AGENDA
CITY PLANNING COMMISSION

REZONING AND BASIC DEVELOPMENT PLAN - The applicant, HARTMAN I, LLC, is requesting approval of a Rezoning to PO (Planned Office) and a Basic Development Plan for a new Medical Facility (RZ BDP 22-13).

Subject: Basic Development Plan and Rezoning – Medical Facility
(7611 Old Troy Pike)

Subject: MJC 22-14 Major Change to Basic Development Plan and Approval of Detailed Development Plan at 6025 Taylorsville Rd.

Exterior Signage Site Plan

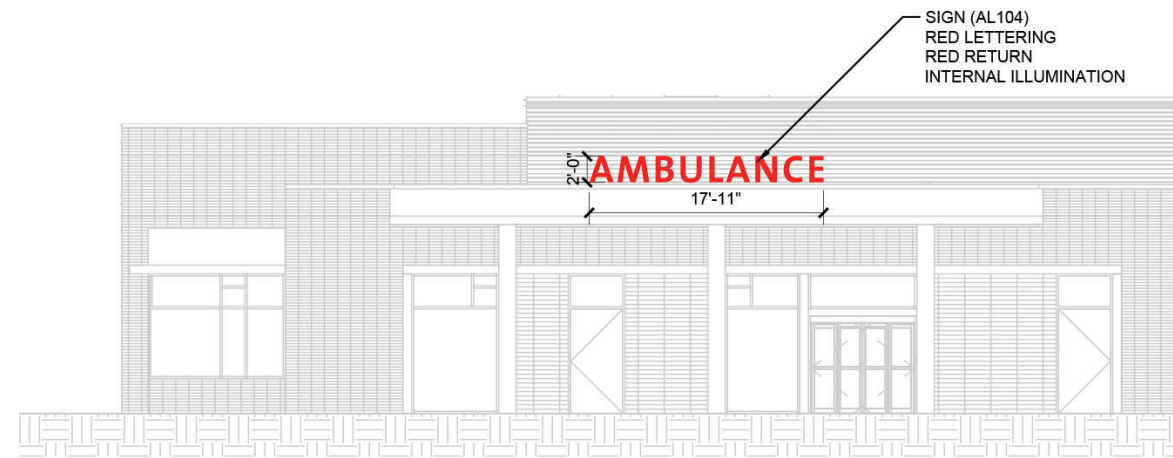
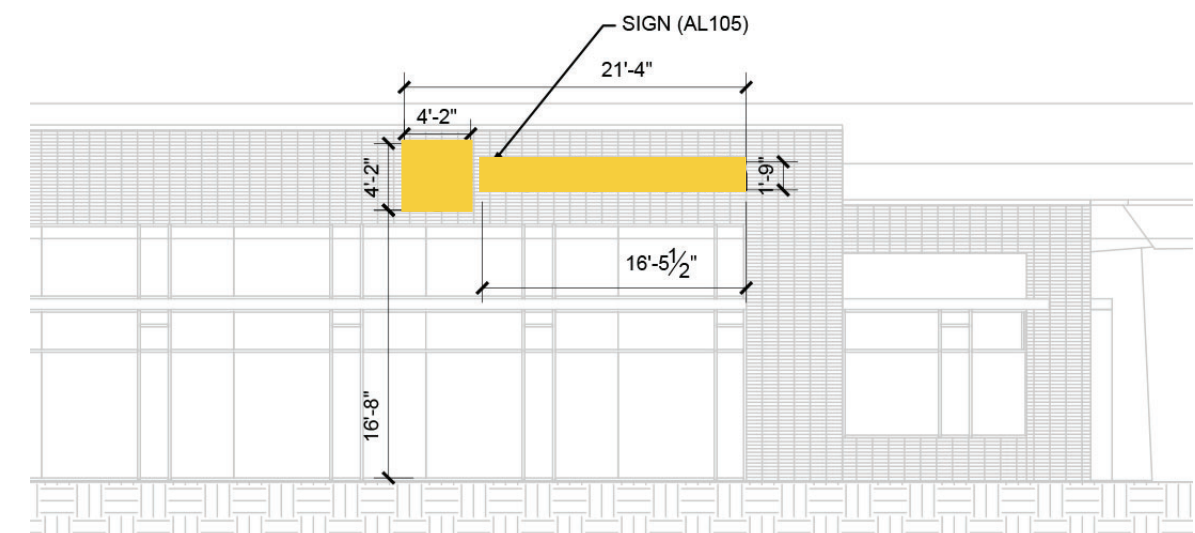
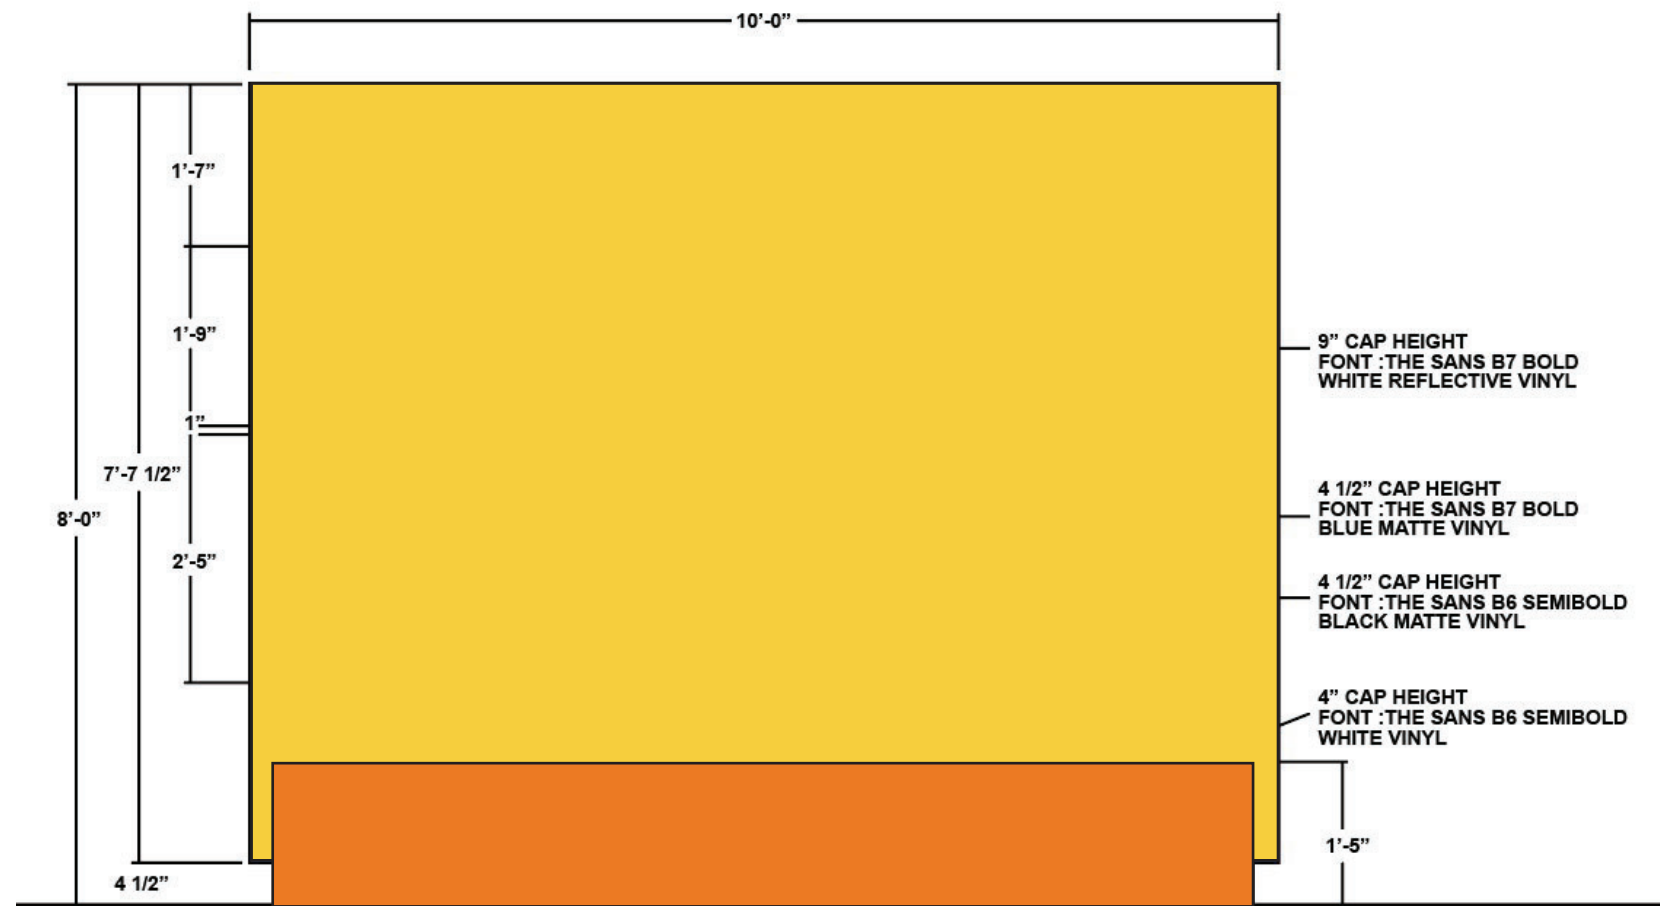
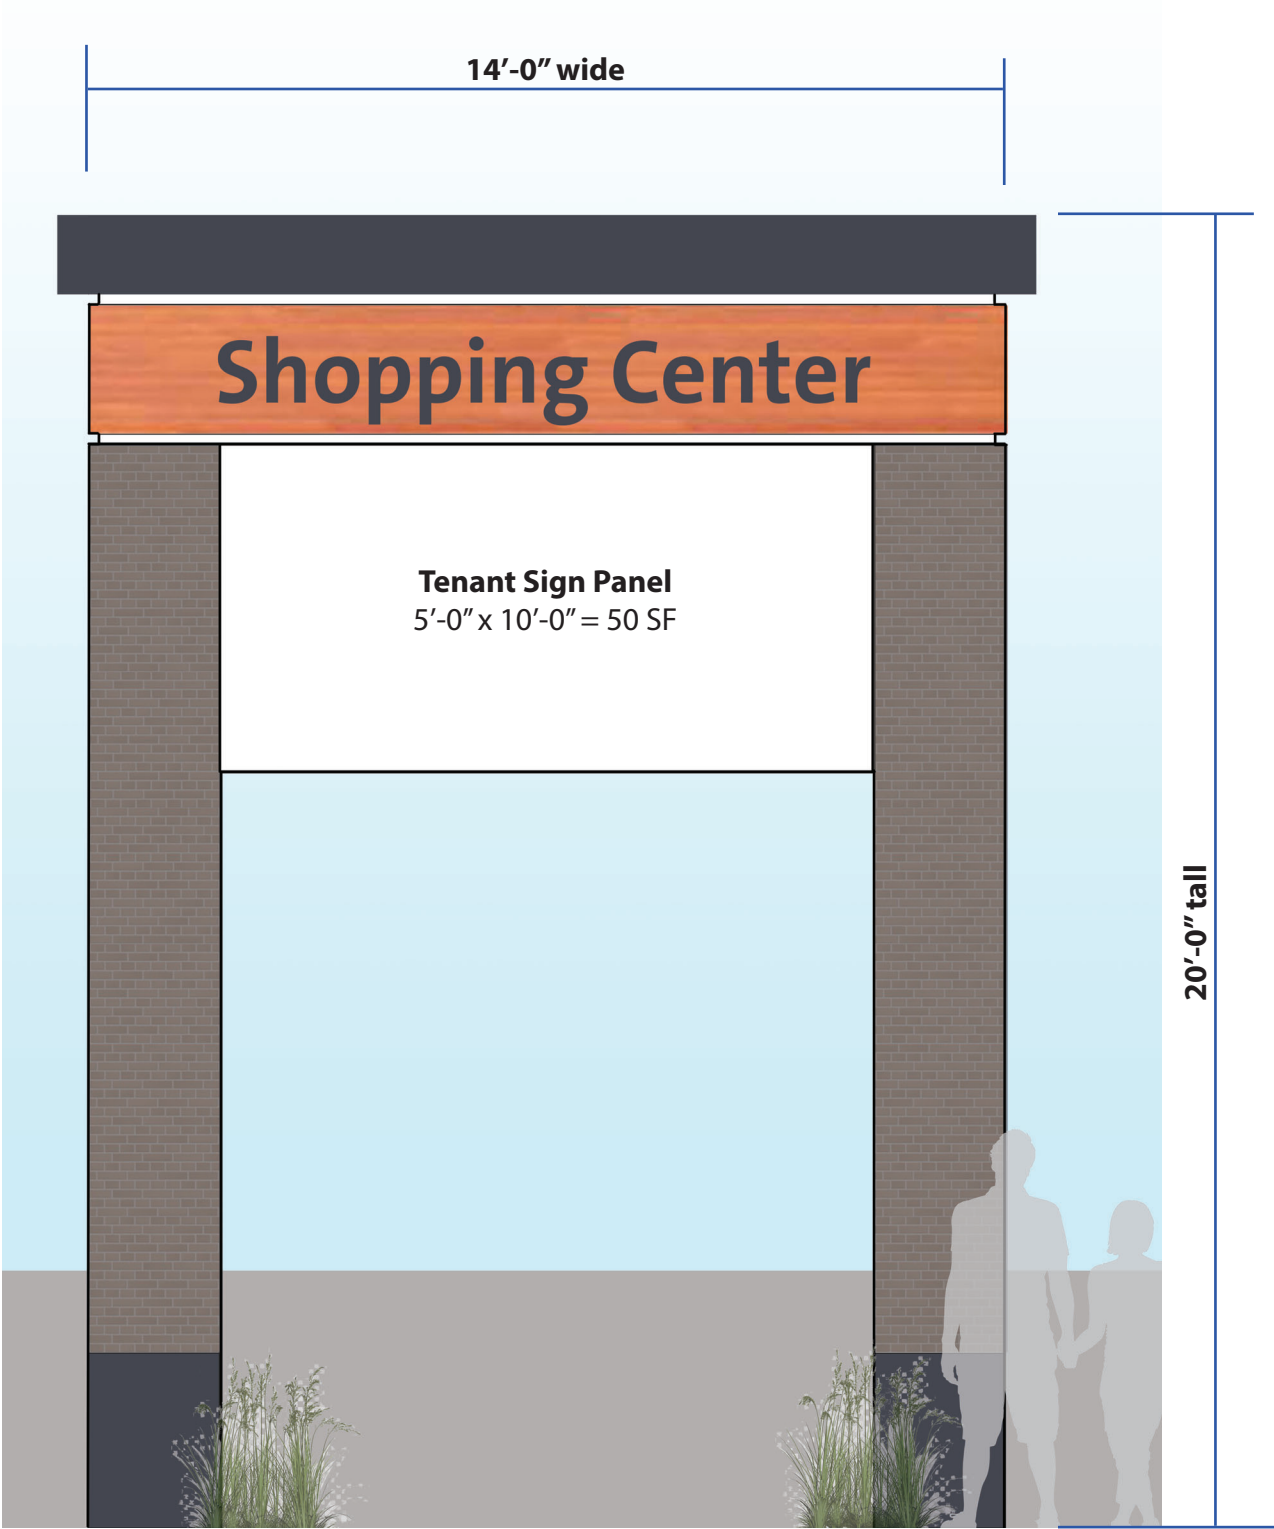
Variance required
Signage to be considered to be
for public health emergency purposes

Variance required for height to be 8' (not 6')
